ZAYO'S PRINEVILLE TO RENO PROJECT

CPUC MINOR PROJECT REFINEMENT FORM

RFI 489

VIEWPORT - 63

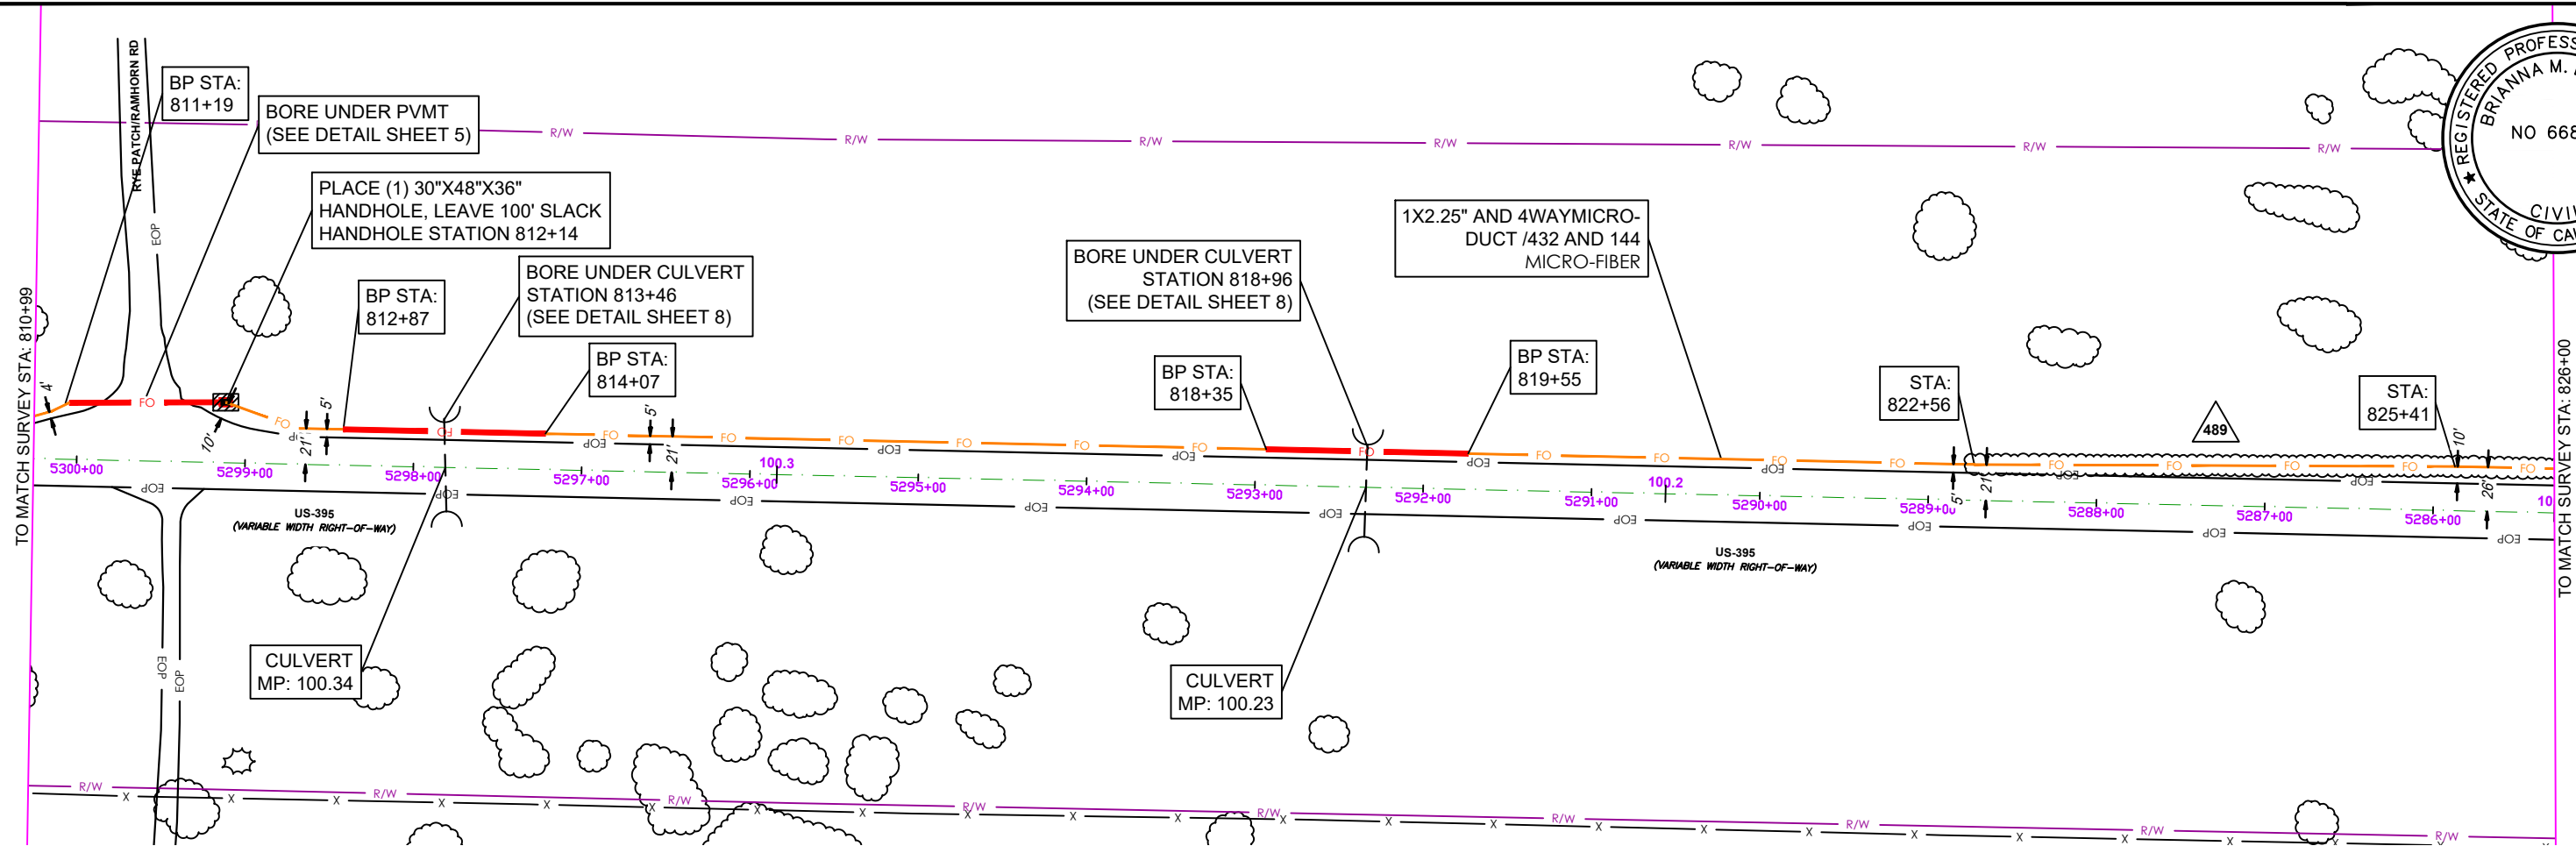
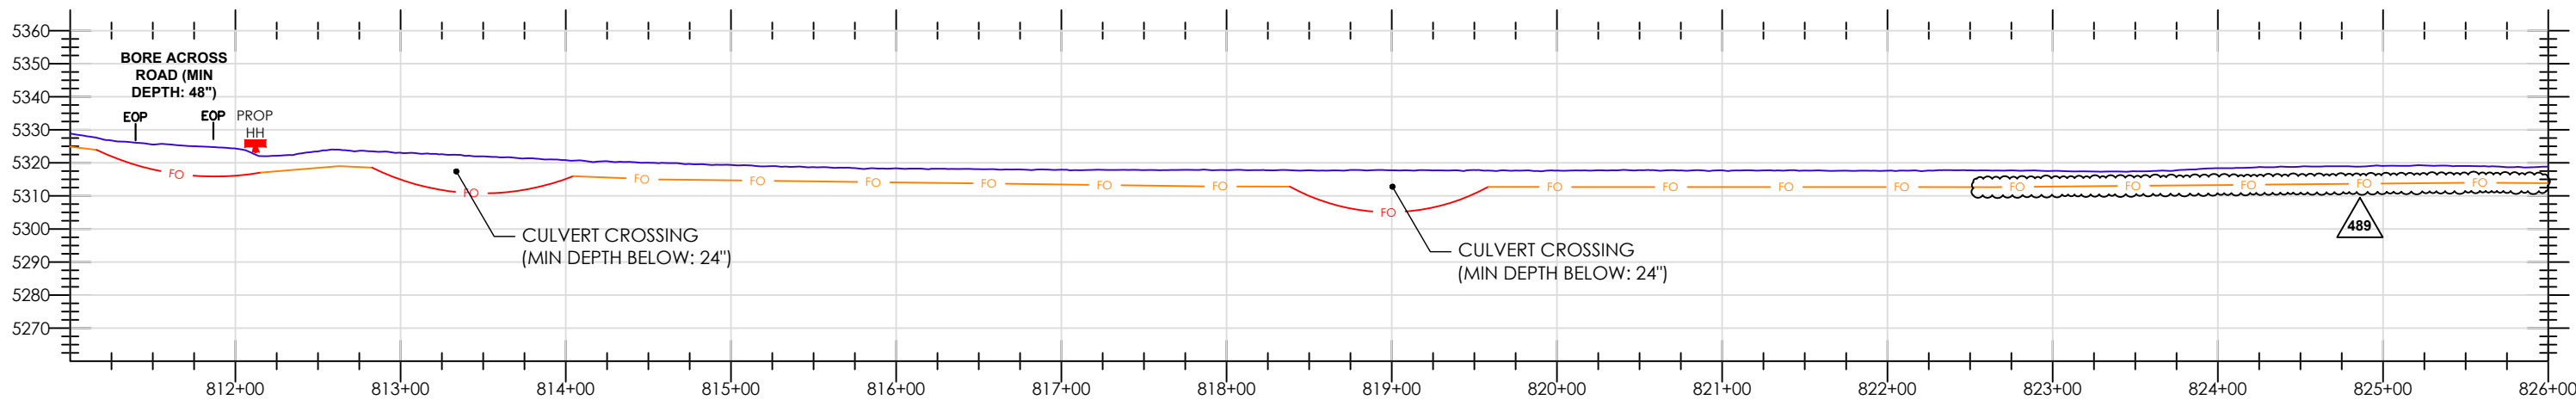
NOTES: FOR TRAFFIC CONTROL REFER TO 2023 CALTRANS STANDARDS AND LATEST EDITION OF CAMUTCD CAUTION RIGHTS-OF-WAY ARE DEPICTED BASED ON LATEST DOT RECORDS AVAILABLE. IF FURTHER ACCURACY IS REQUIRED, LAND SURVEYS WILL BE NECESSARY	RFI NO. 0489 DEVIATE R/L TO 10' - 4' FROM EOP TO AVOID TREE LINES AND ROCK STA 821+50 TO 856+34	12/16/2024

VIEWPORT - 64

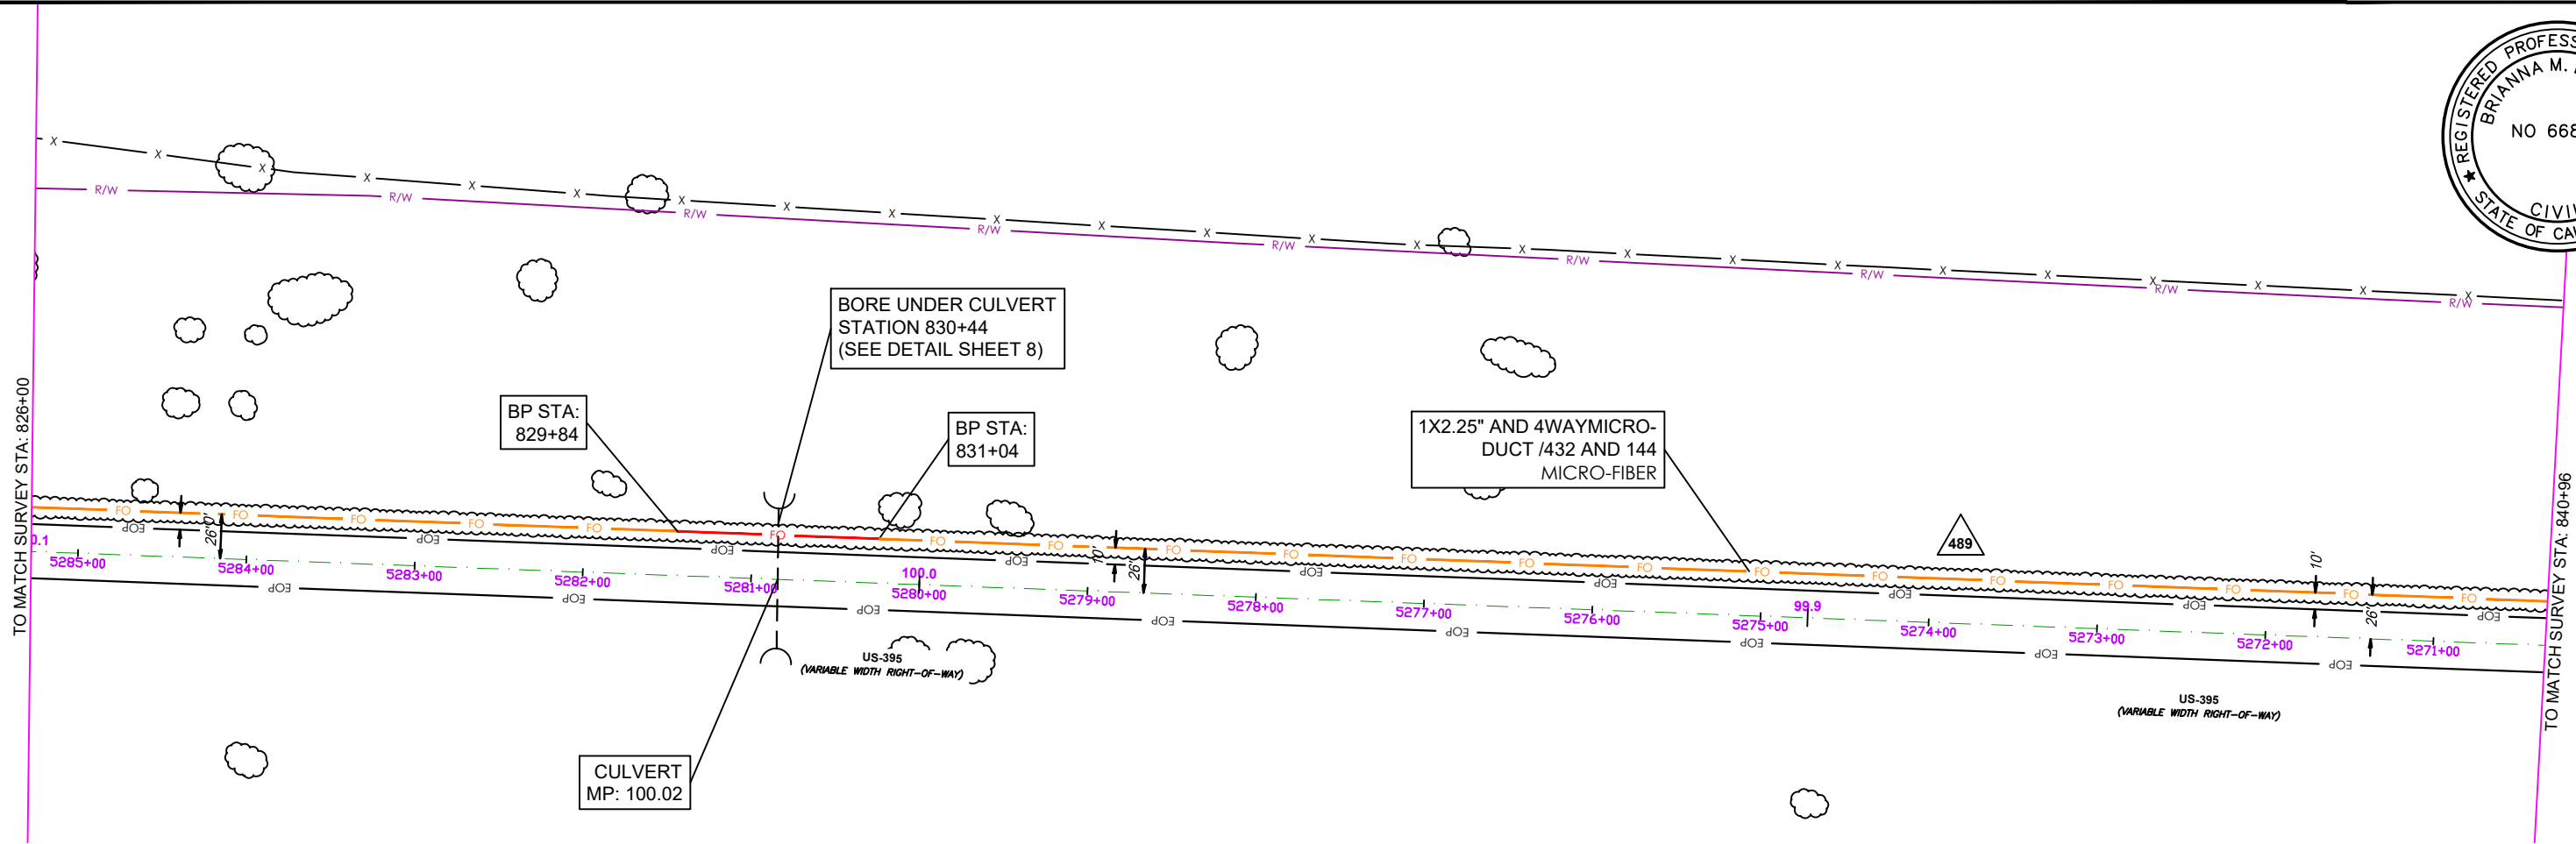
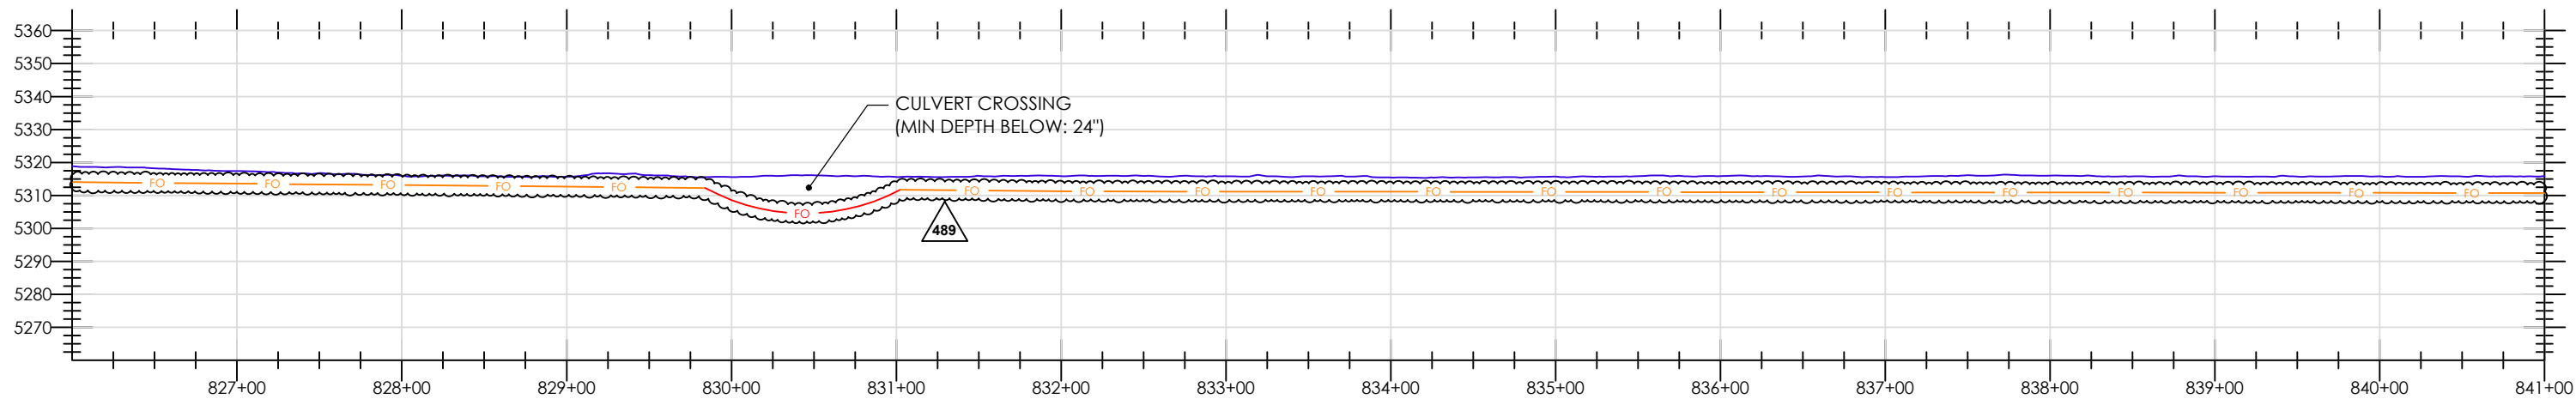
NOTES: FOR TRAFFIC CONTROL REFER TO 2023 CALTRANS STANDARDS AND LATEST EDITION OF CAMUTCD CAUTION RIGHTS-OF-WAY ARE DEPICTED BASED ON LATEST DOT RECORDS AVAILABLE. IF FURTHER ACCURACY IS REQUIRED, LAND SURVEYS WILL BE NECESSARY	RFI NO. 0489 DEVIATE R/L TO 10' - 4' FROM EOP TO AVOID TREE LINES AND ROCK STA 821+50 TO 856+34	12/16/2024

VIEWPORT - 65

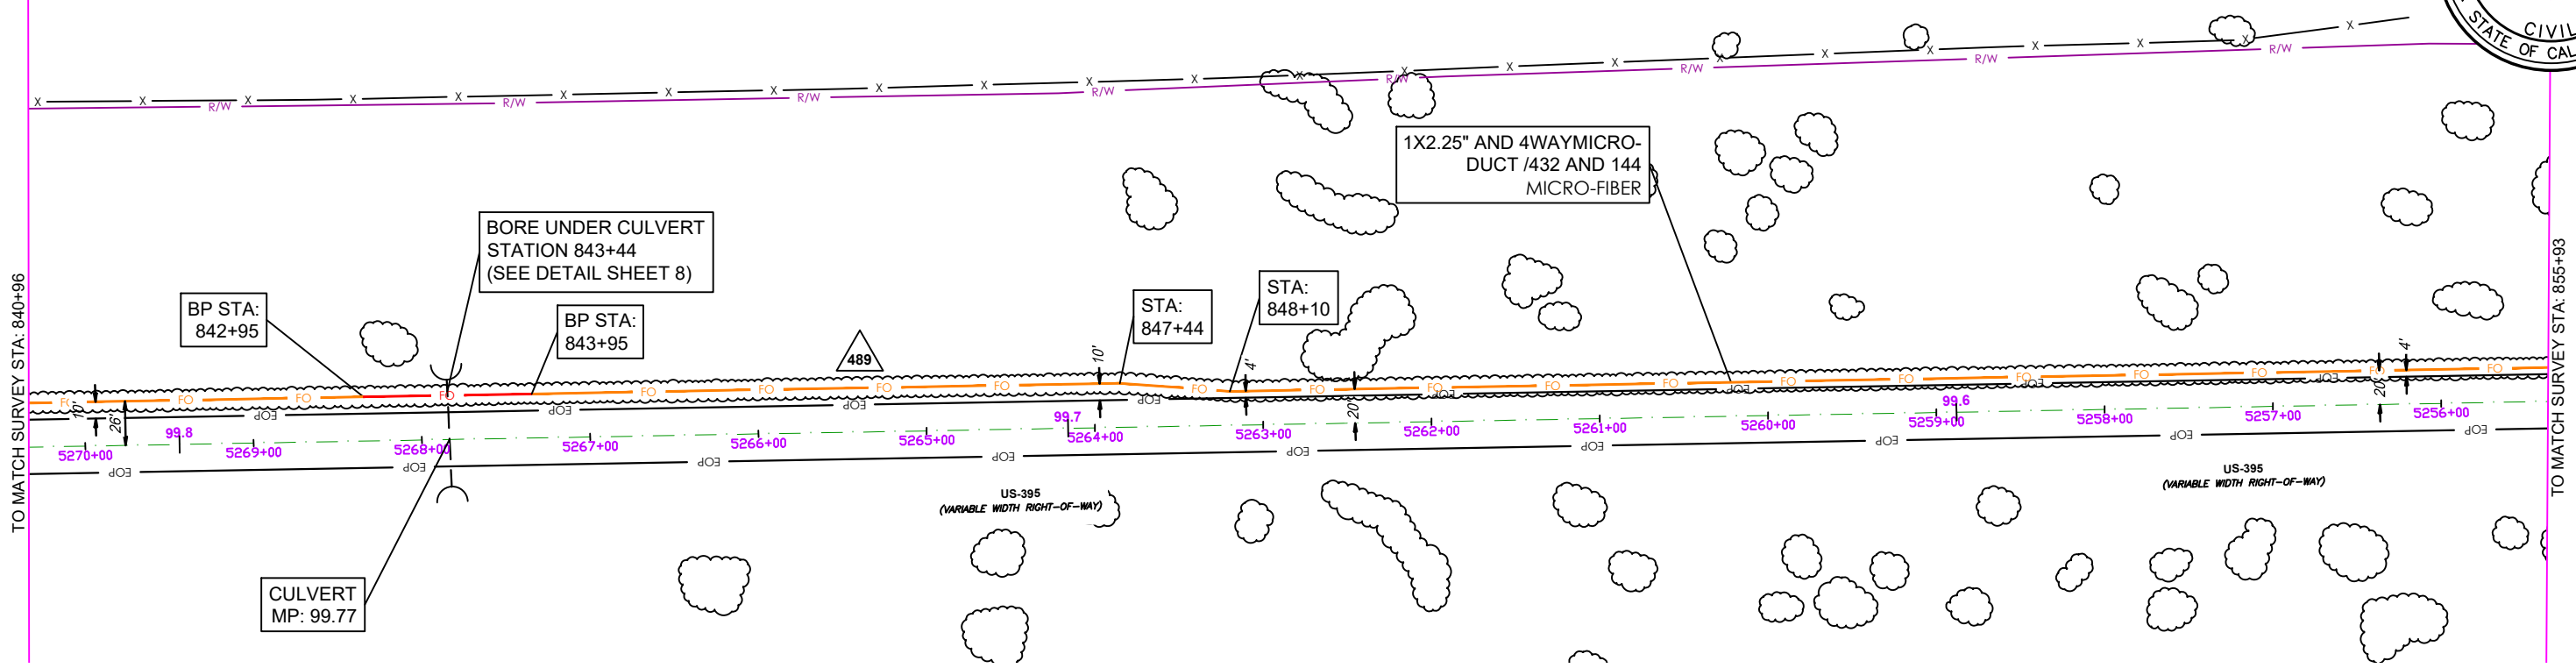
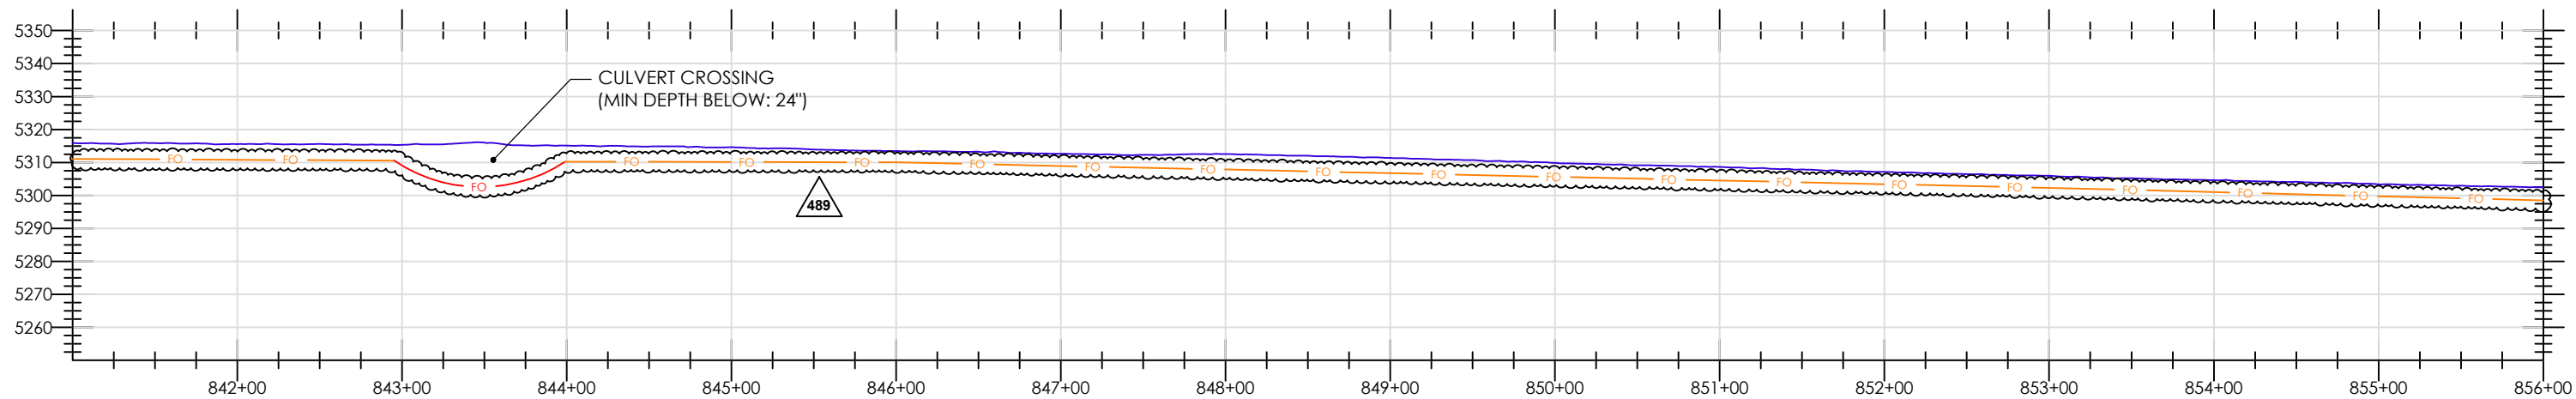
NOTES: FOR TRAFFIC CONTROL REFER TO 2023 CALTRANS STANDARDS AND LATEST EDITION OF CAMUTCD CAUTION RIGHTS-OF-WAY ARE DEPICTED BASED ON LATEST DOT RECORDS AVAILABLE. IF FURTHER ACCURACY IS REQUIRED, LAND SURVEYS WILL BE NECESSARY	RFI NO. 0489 DEVIATE R/L TO 10' - 4" FROM EOP TO AVOID TREE LINES AND ROCK STA 821+50 TO 856+34	12/16/2024
